**City of Phoenix
Office of the City Engineer
Design and Construction Procurement**

**LIFT STATION 76 PHASE II EXPANSION
WS90400067**

ADDENDUM NO. 3

ISSUE DATE: APRIL 25, 2024

SECTION C
SCALE: 1/2" = 1'-0"

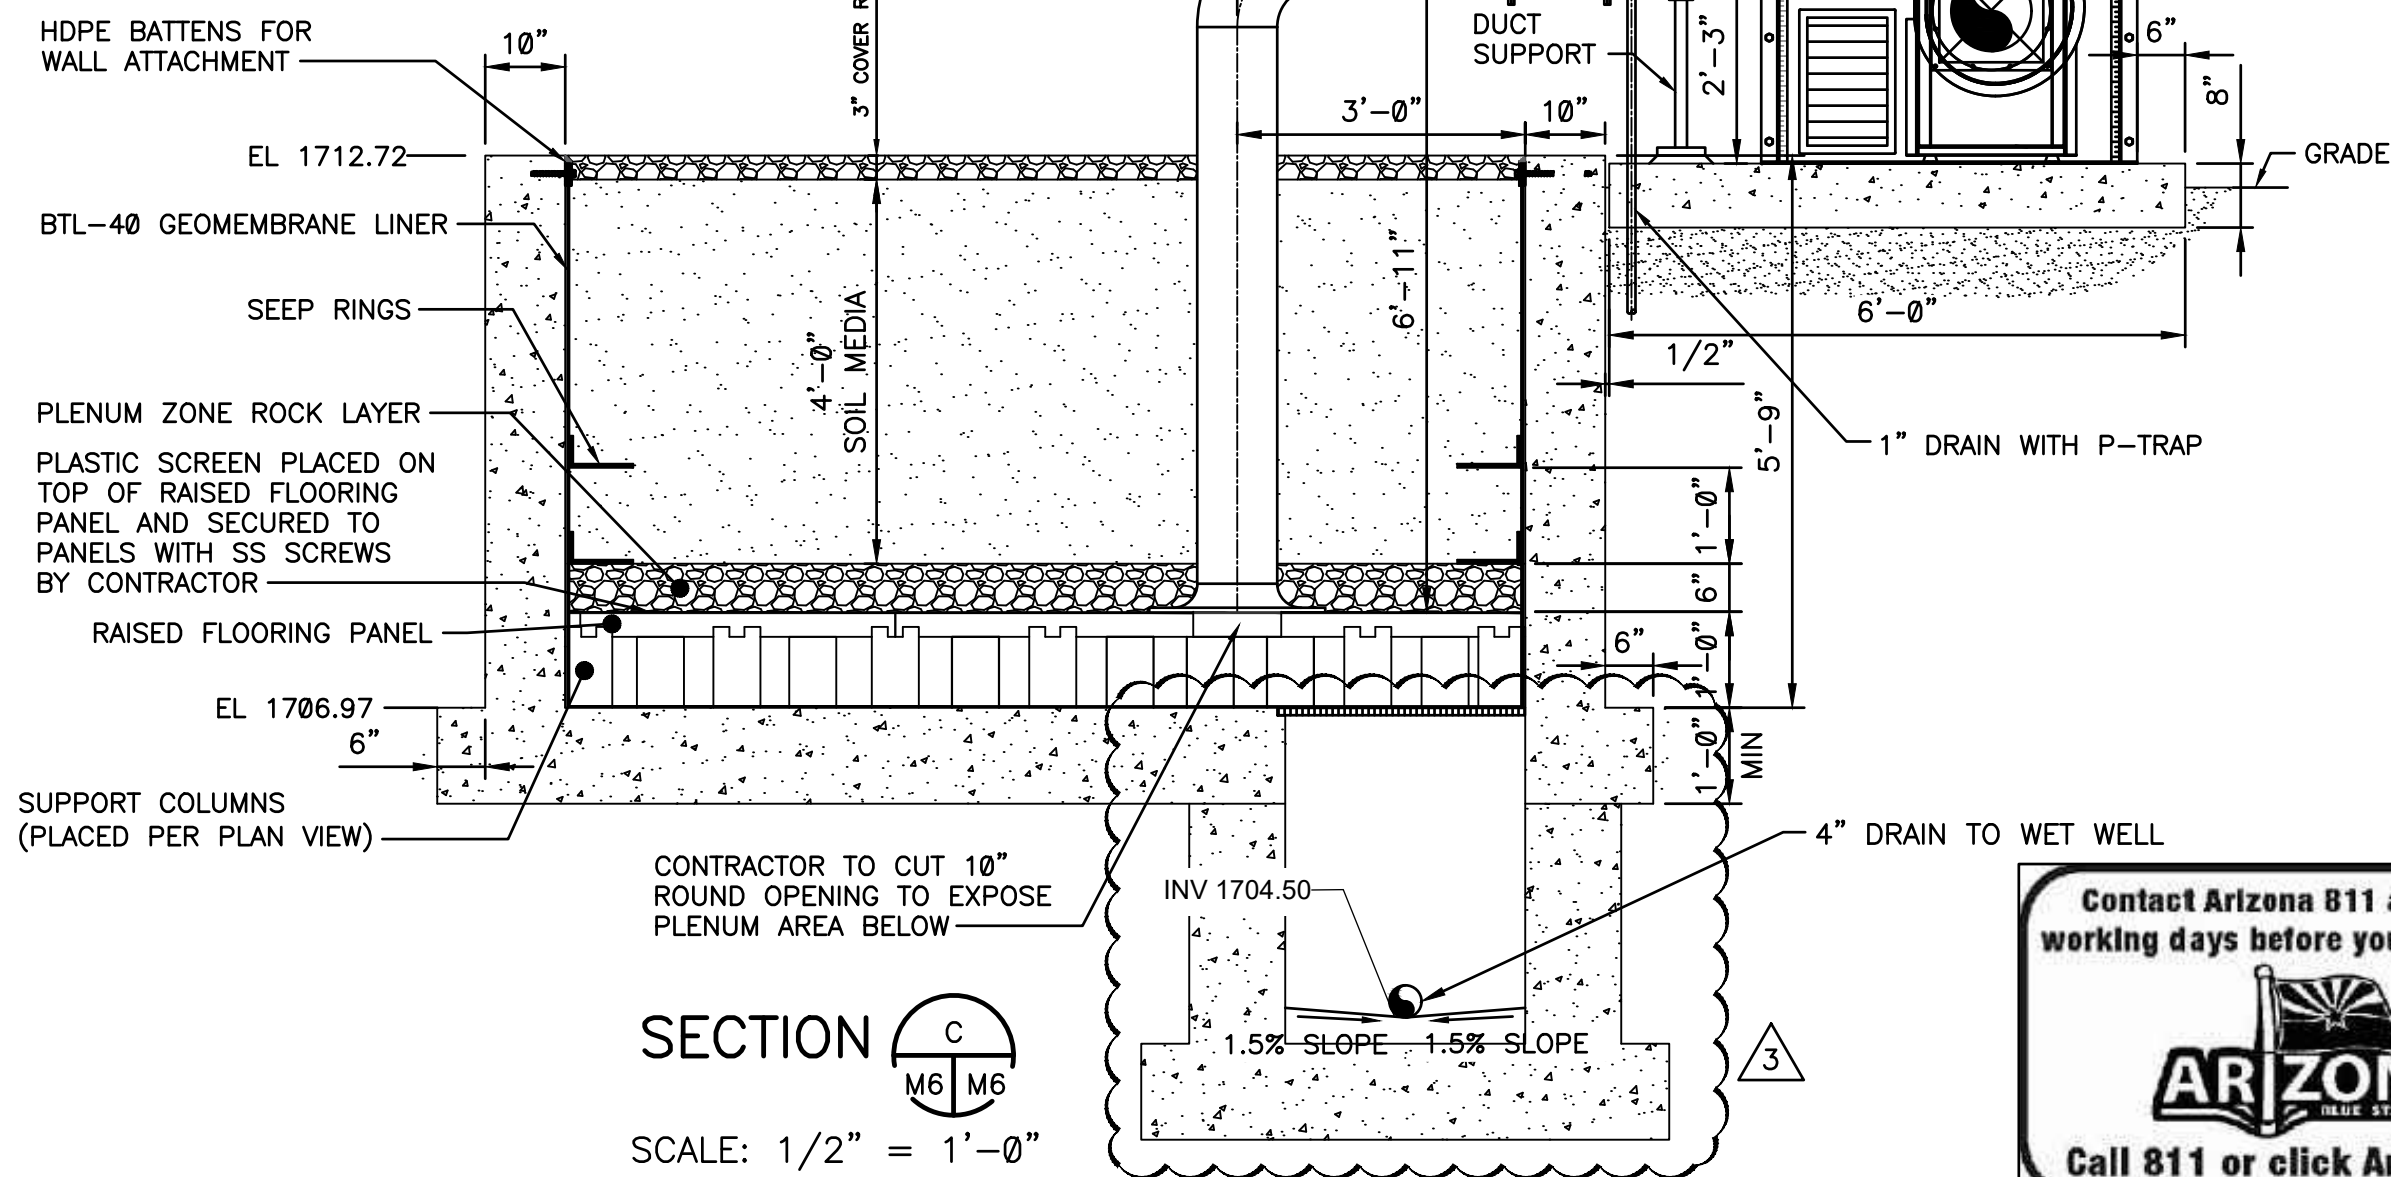
28. **PROJECT TECHNICAL DRAWINGS:** **DELETE** Sheet M06 in it's entirety and **REPLACE** with attached Revised Sheet M06, modifications are clouded.
29. **PROJECT TECHNICAL DRAWINGS:** **DELETE** Sheet M09 in it's entirety and **REPLACE** with attached Revised Sheet M09, modifications are clouded.
